Report No DS-2024-0052
Attachment 2
Page 1 of 1

THE CORPORATION OF THE TOWN OF GEORGINA IN THE REGIONAL MUNICIPALITY OF YORK

BY-LAW NUMBER 2024-__ (PL-5)

Subject: Application for Draft Plan of Subdivision, Zoning By-law

13. DRAWING G-2 AND G-3

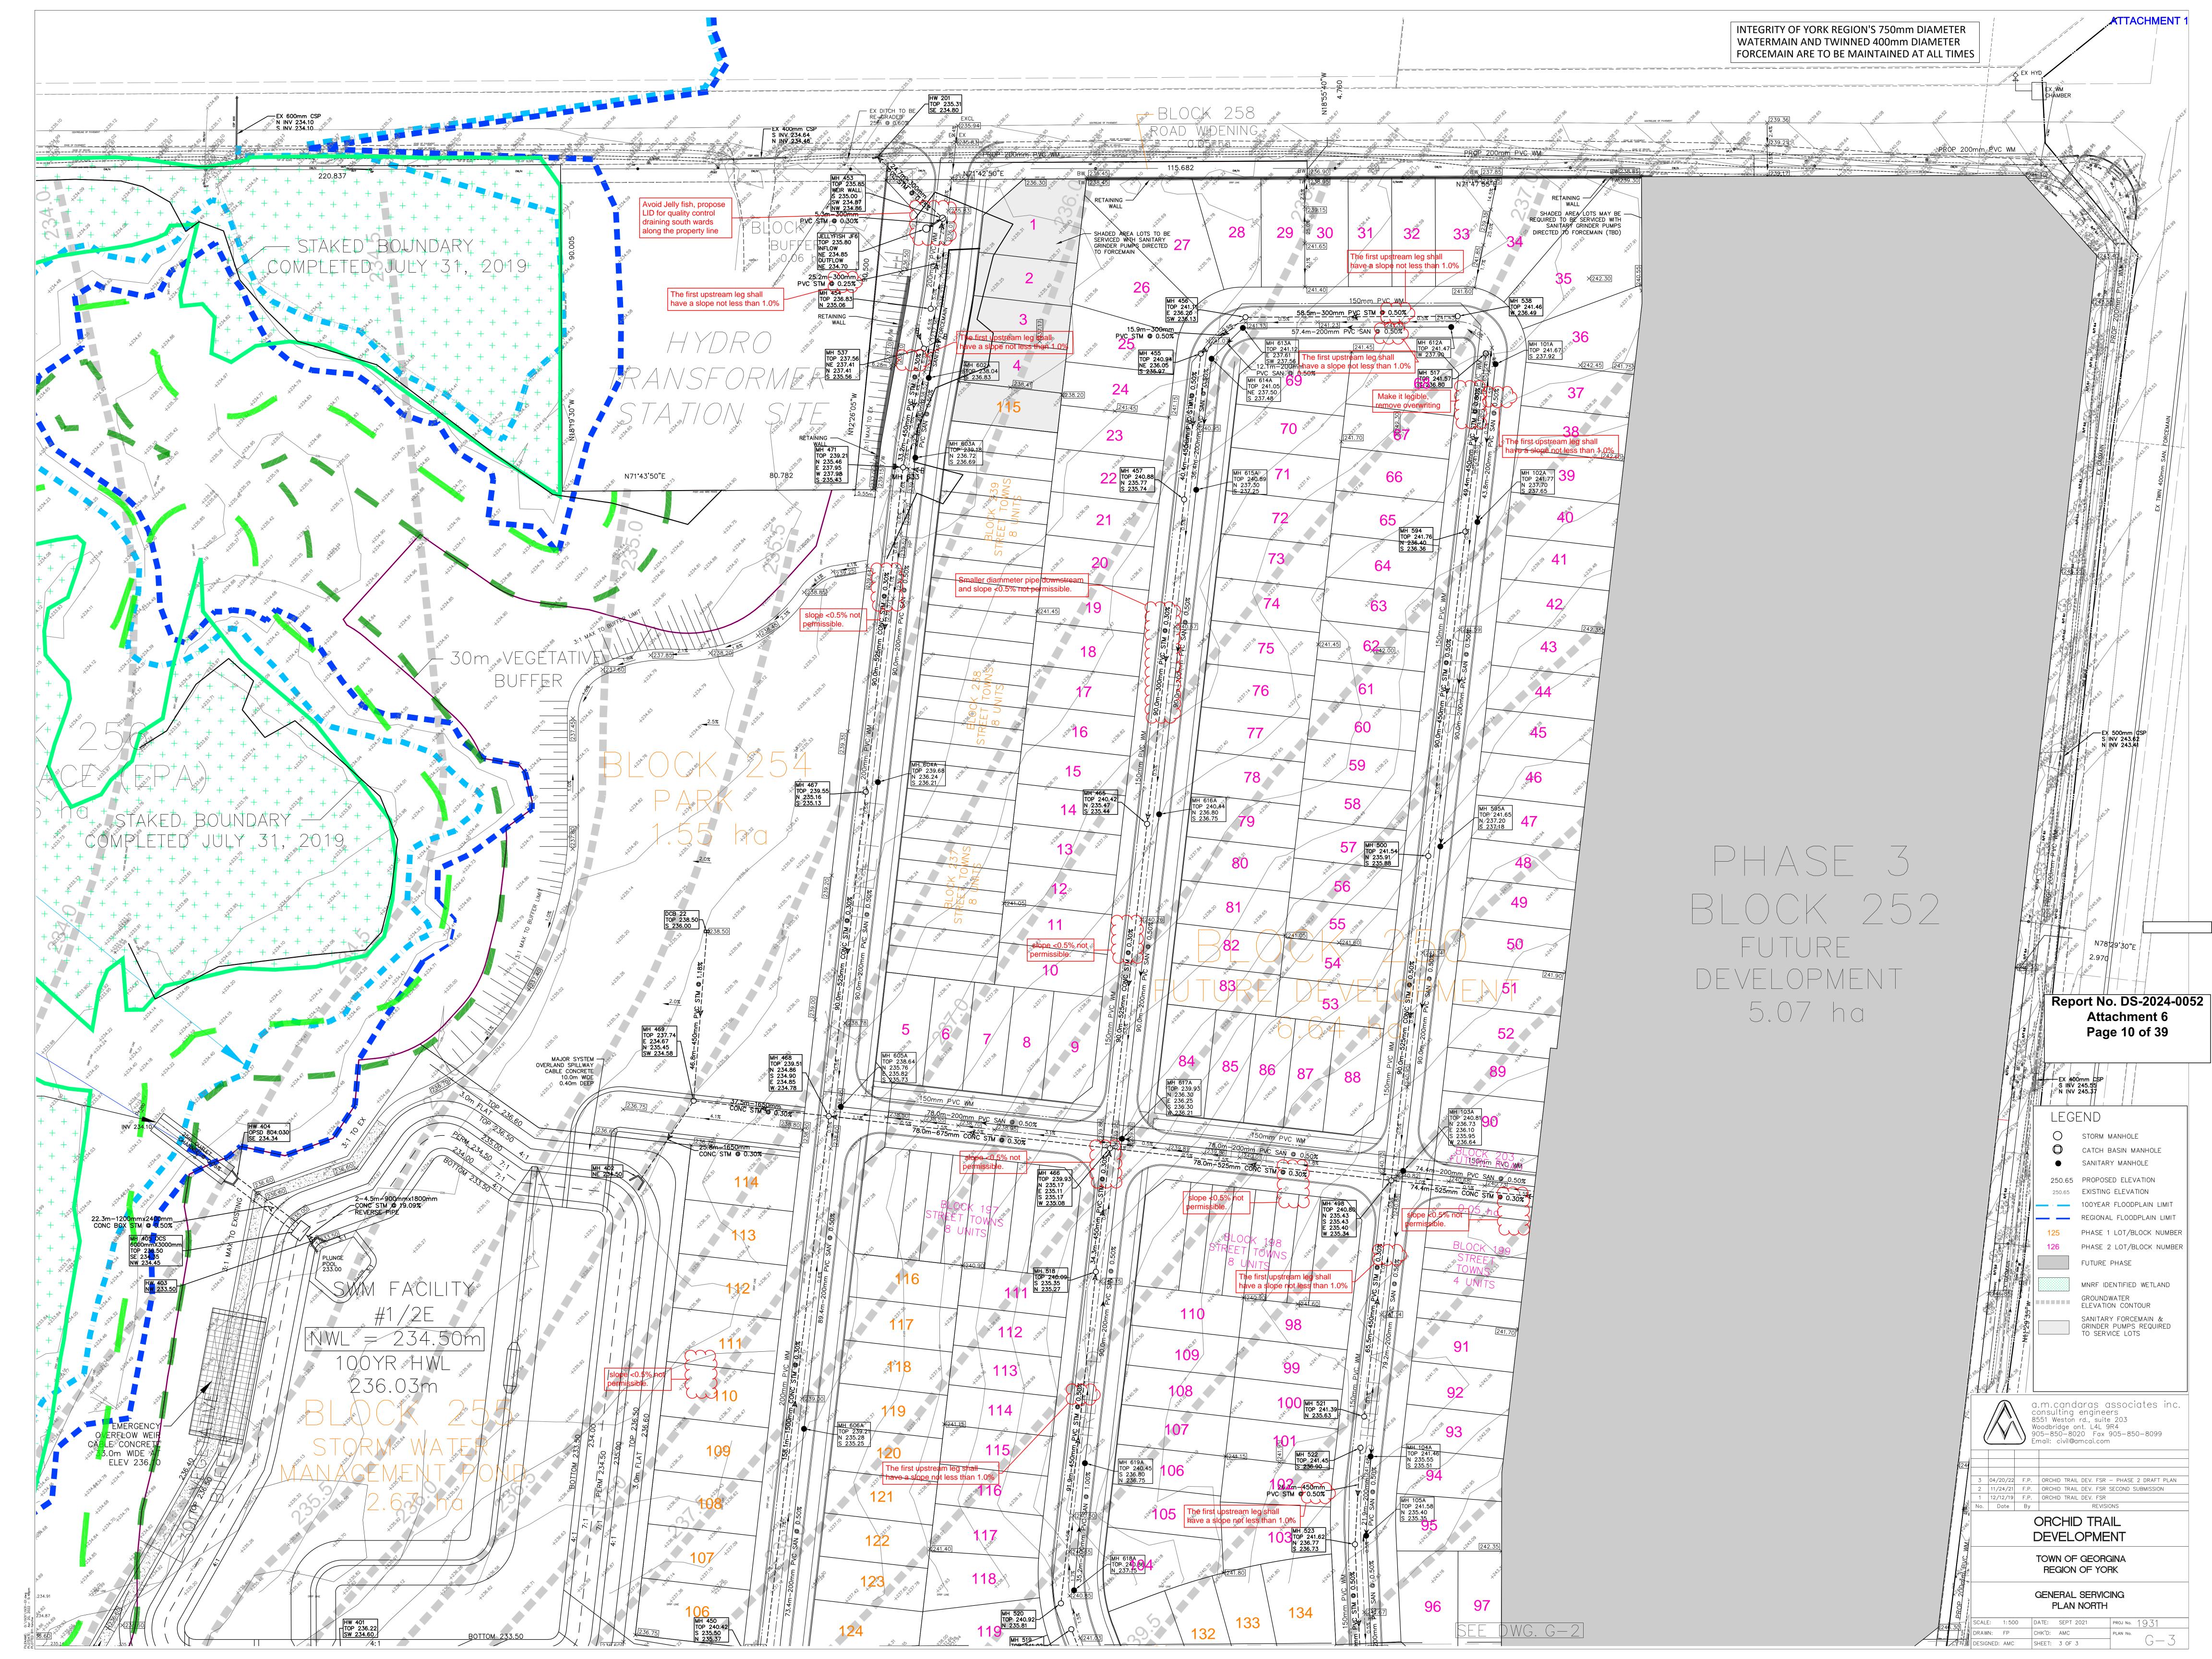
i. Why there are no curb and gutter shown on the southern section of Street F? Please clarify. See redlined drawings.

Storm Sewers

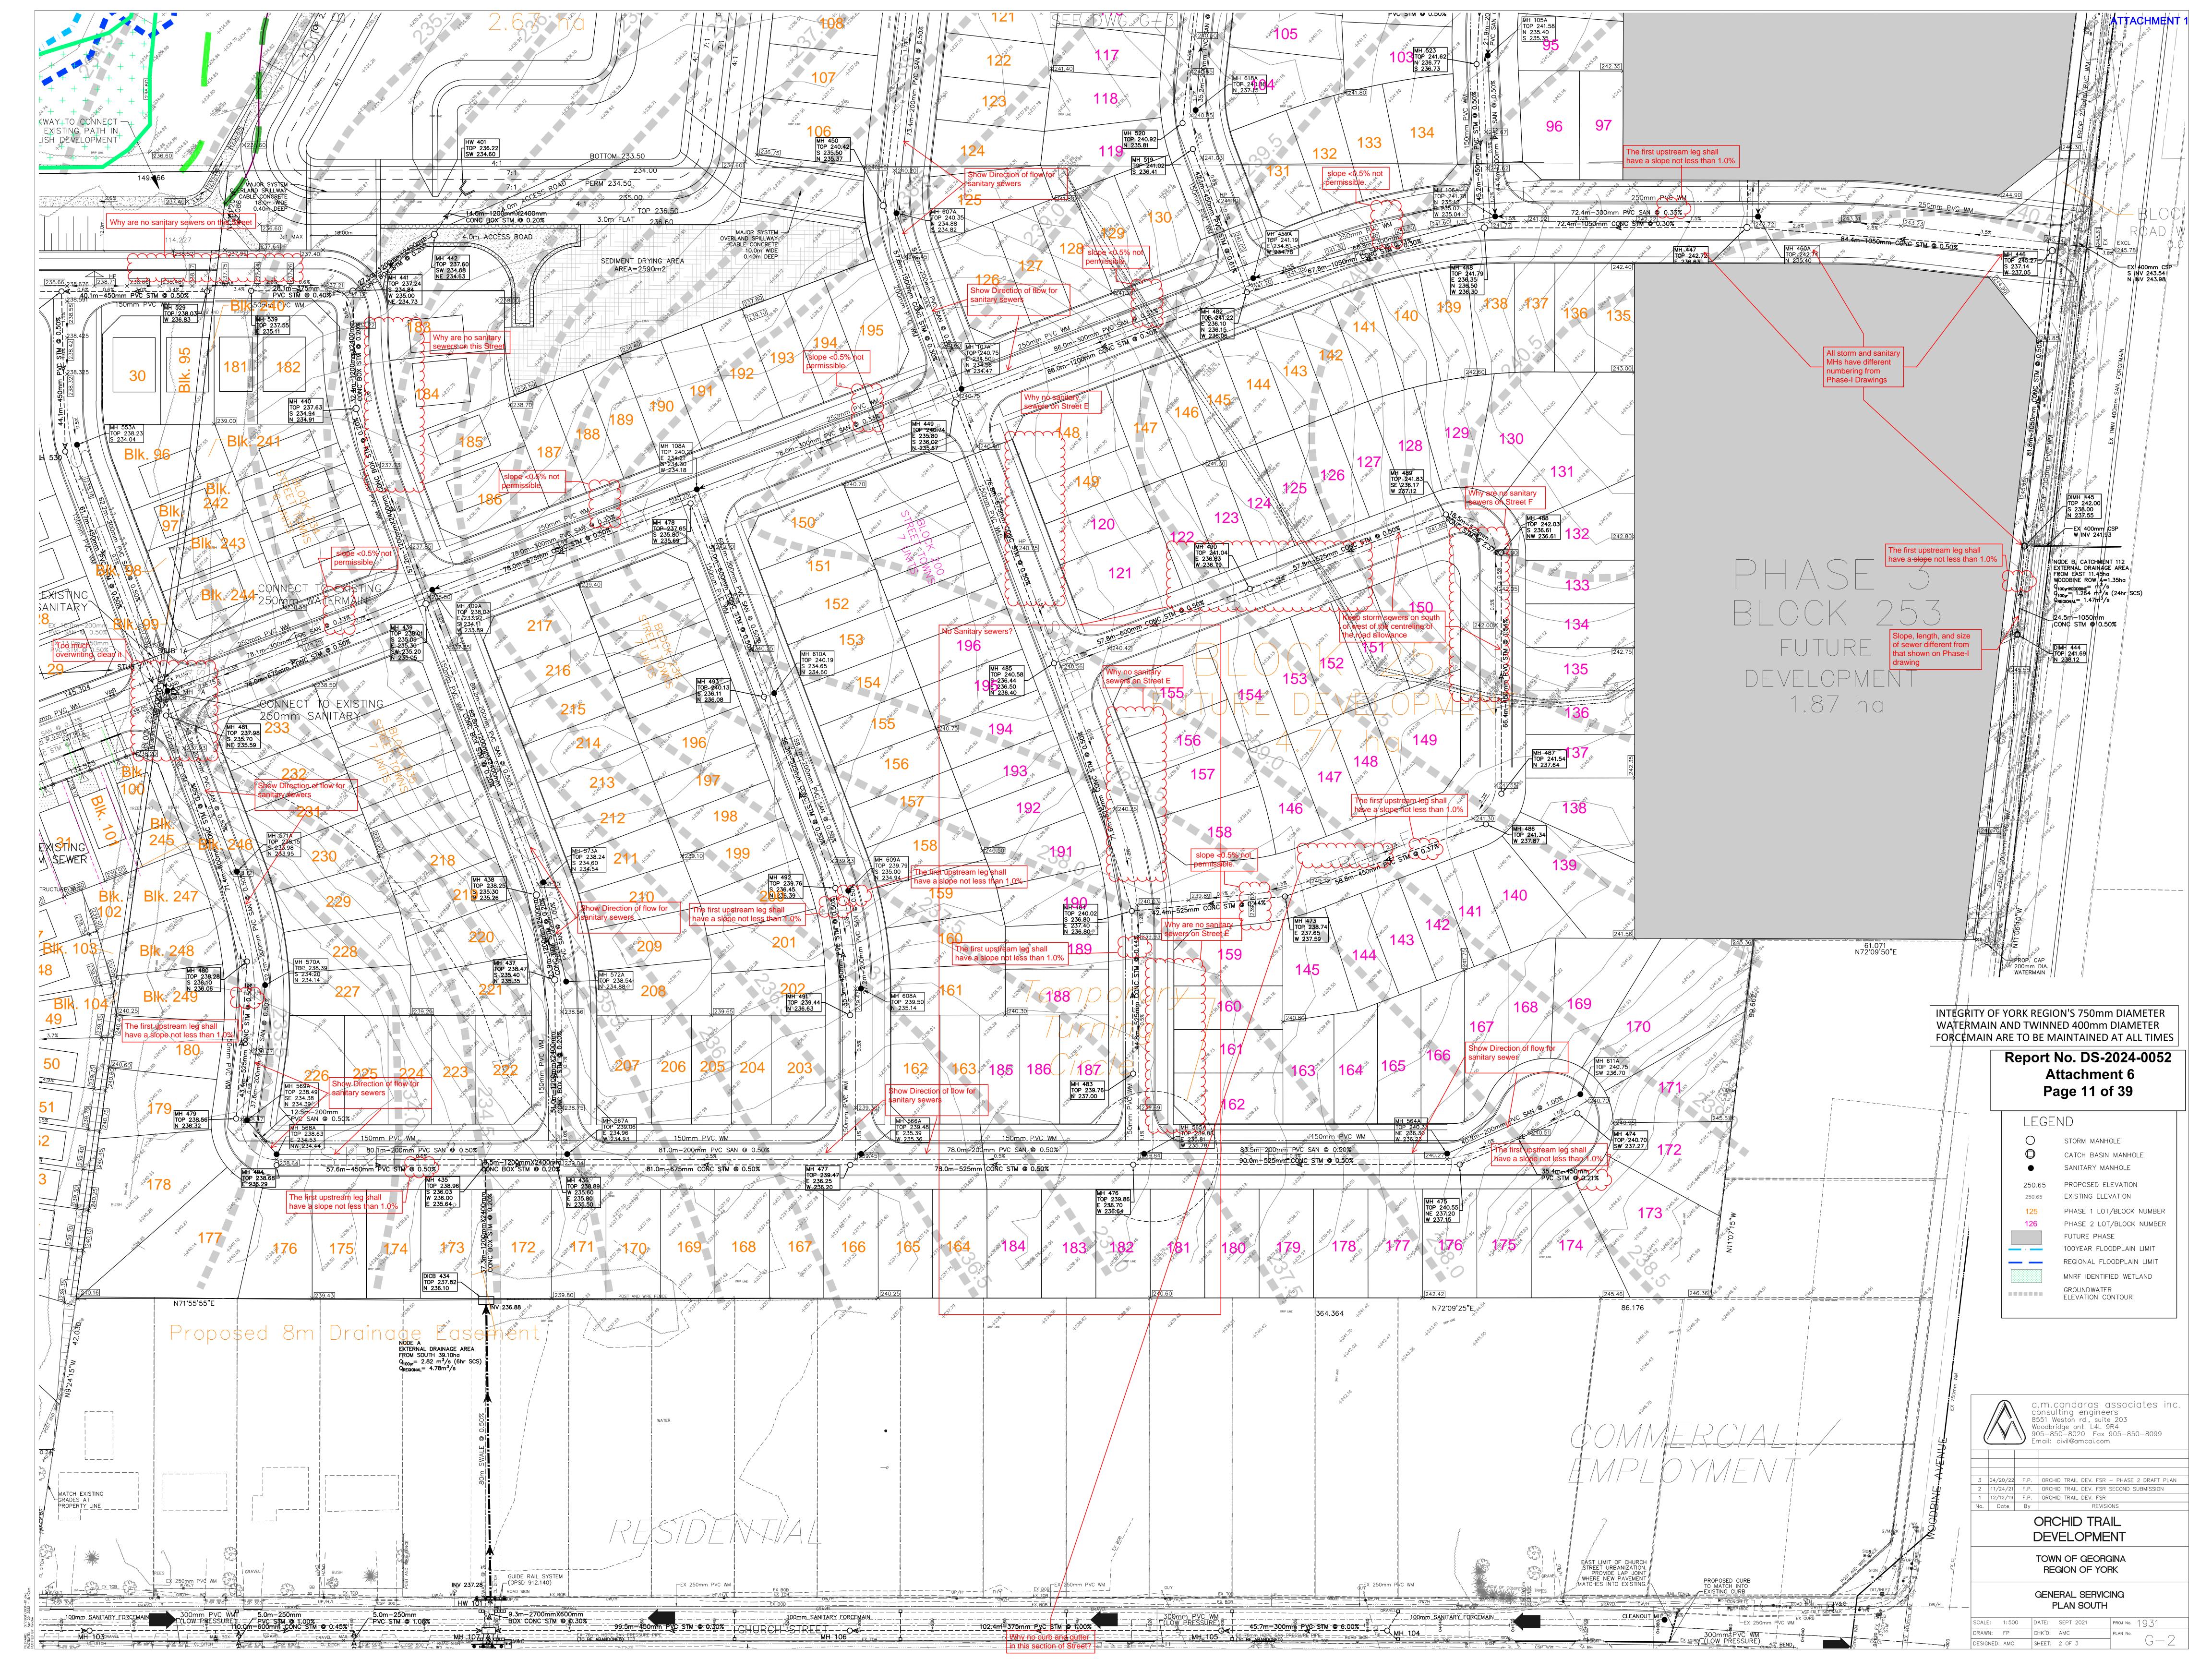
- i. Keep storm sewers on the south or west of the centreline of the road allowance, Street F. See redlined drawings.
- ii. No decrease of pipe size from a larger upstream pipe to a smaller downstream size will be allowed.
- iii. The first upstream leg shall have a slope not less than 1.0% and be a length of not less than 50 m., unless the designer demonstrates that the minimum velocity of 0.8m/s is being achieved. See redlined drawings.
- iv. Minimum gradient required for pipes sizes 600mm and smaller is 0.5 %. Design criteria Section 24.1.6 Minimum and Maximum Grades

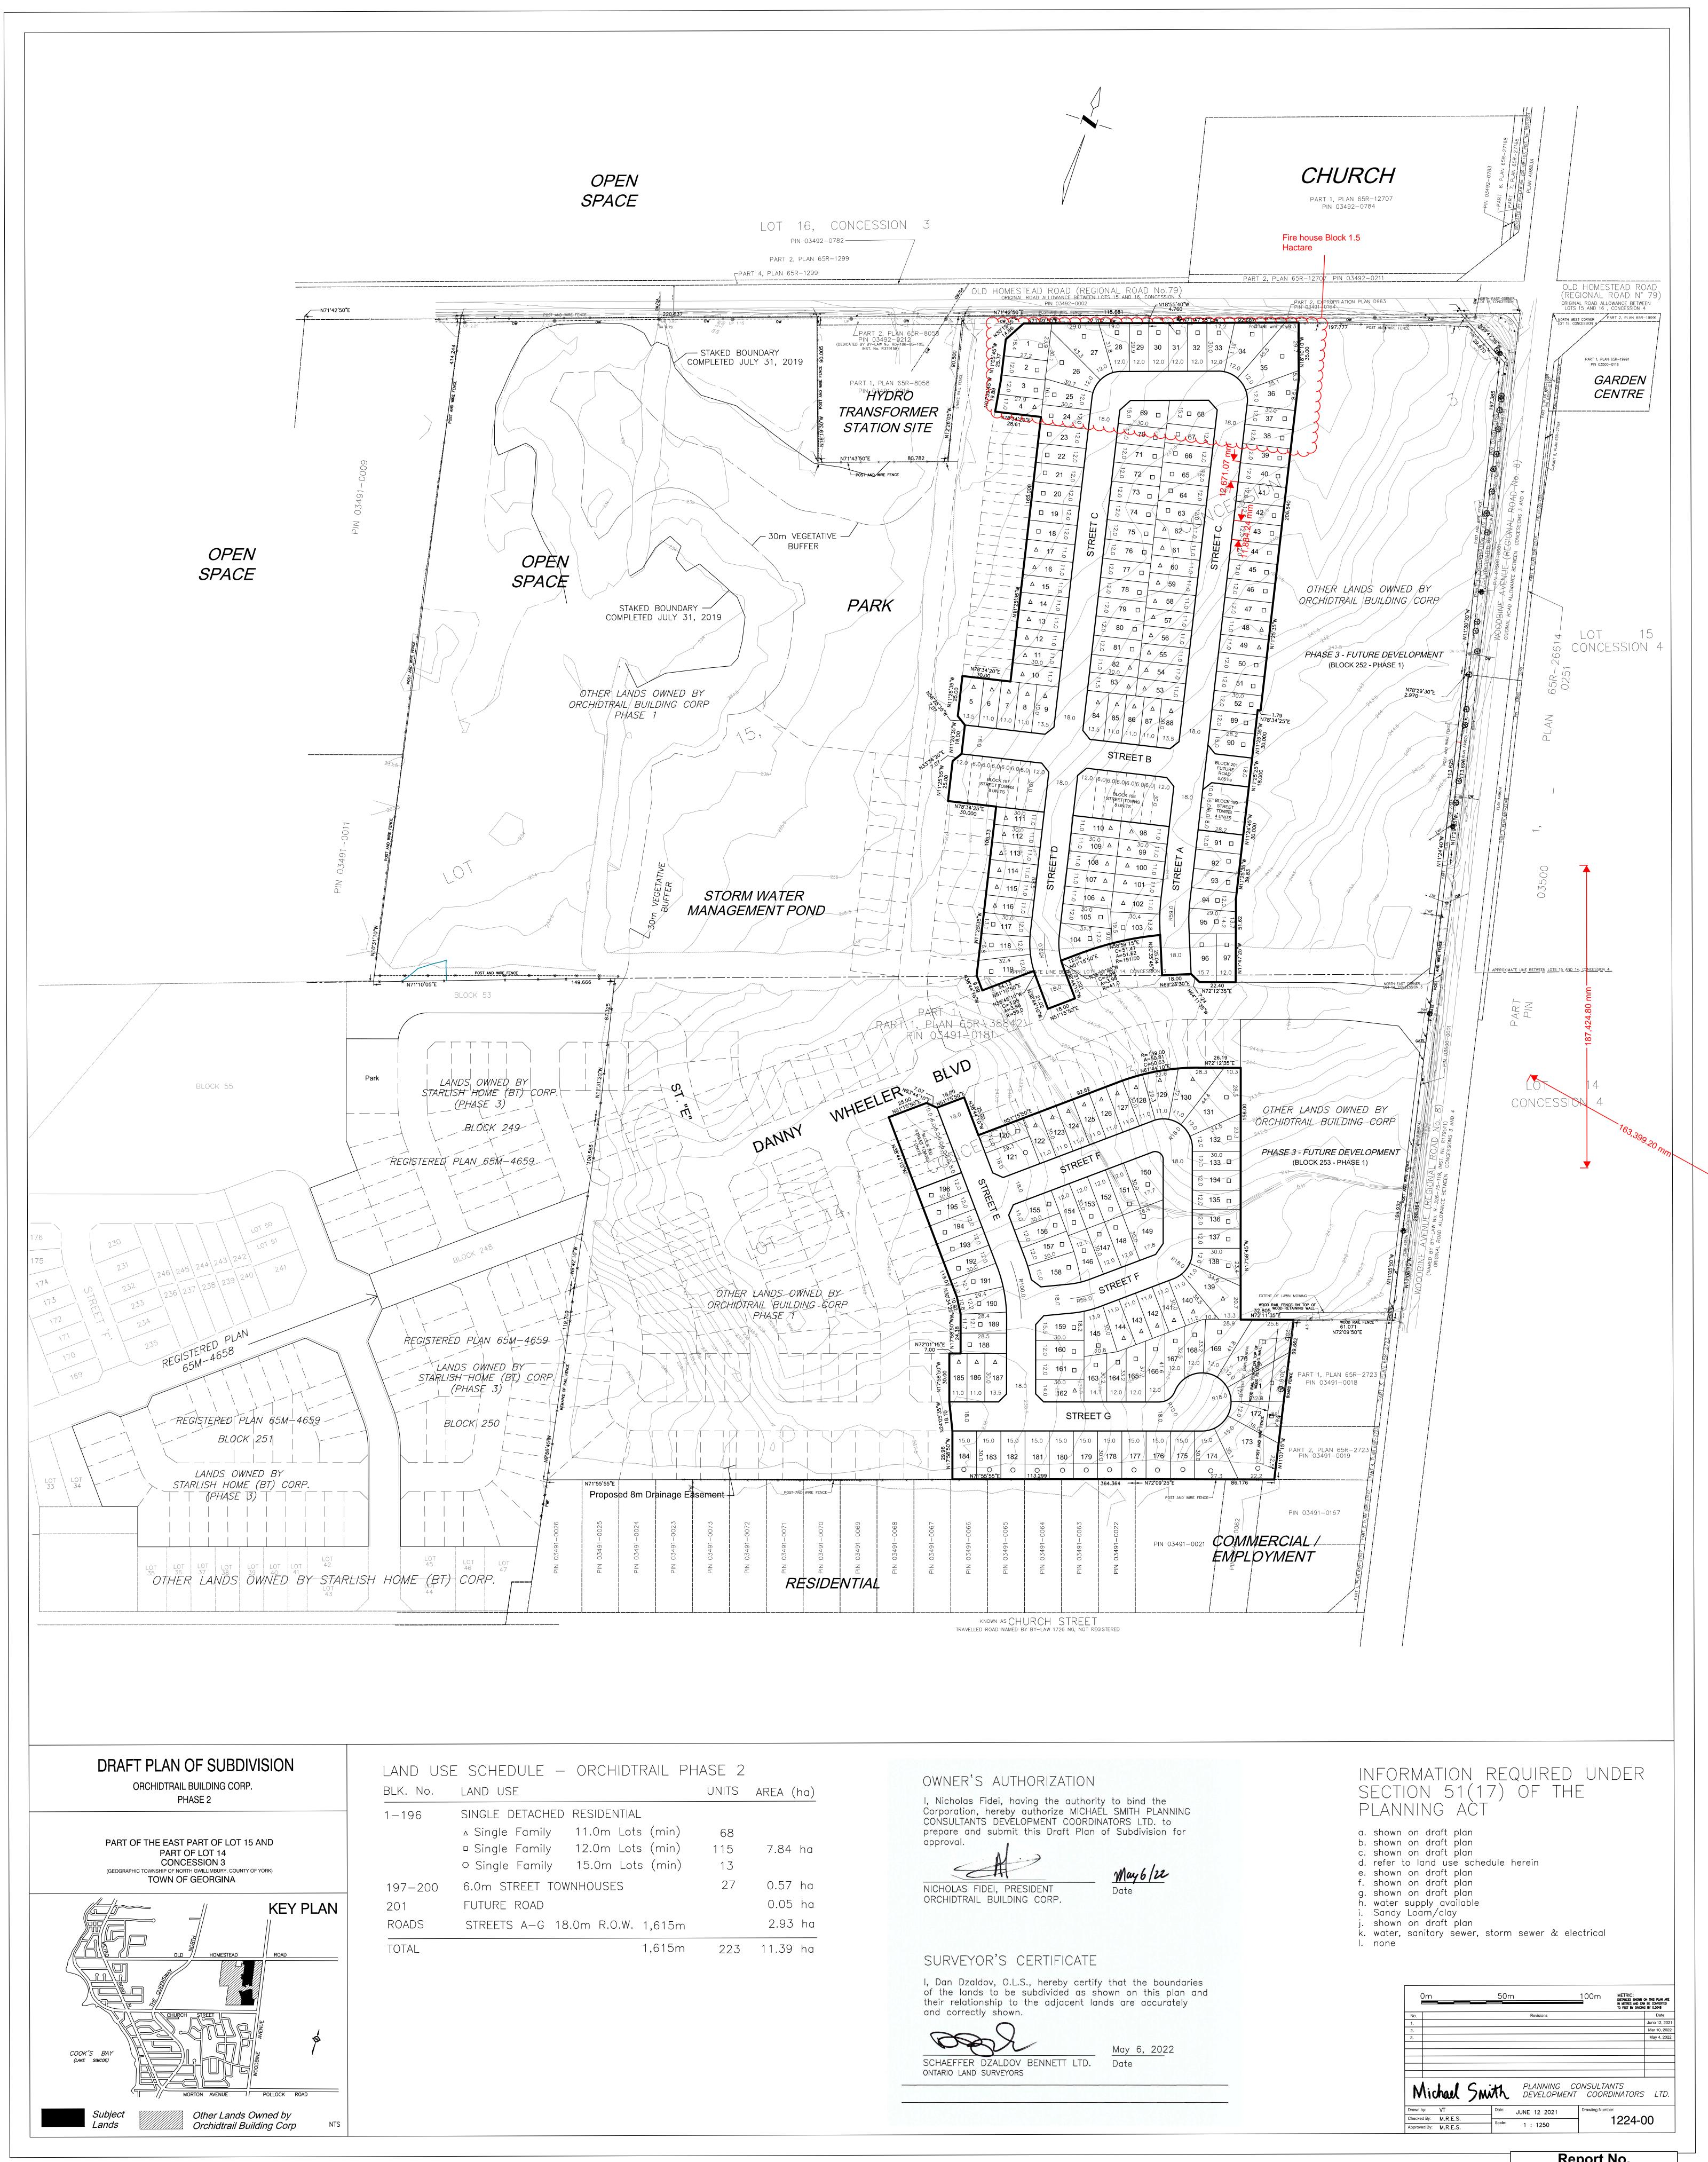
v. The storm sewers data along the Woodbine- size, slope, lengths, nomenclature do not match with the data provided in the Drainage Area Plan S1 for Phase 1.
